NUMBER: 80-6

DATE: 1/31/80

- A. Use of Formula 50-D Oil in Older Mercury Outboards
- B. Starter Rewind Replacement Kit - Merc 40-50
- C. Vapor Lock Elimination - Merc 40-70
- D. Cleaning Gear Housing Speedometer Pickup

**Figure 1. Hole in Check Valve**

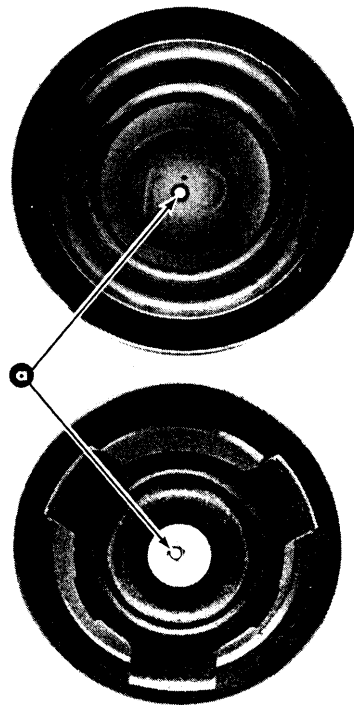
Occasional complaints are heard from customers regarding fuel vapor locking of Merc 40 and 70 outboards during very hot weather. This usually causes the engine to die on acceleration after it has been run and then shut down for a short time. To eliminate this problem, drill a .031" dia. (No. 68 drill) hole in the center of both fuel pump check valves. (Figure 1) If you do not choose to drill the holes, the check valves can be replaced with new check valves (Part No. C-21-92346A3).

a - .031"(1/32"or .787mm) Hole Drilled in Check Valve

**C-21-92346A3      Check Valve Kit**
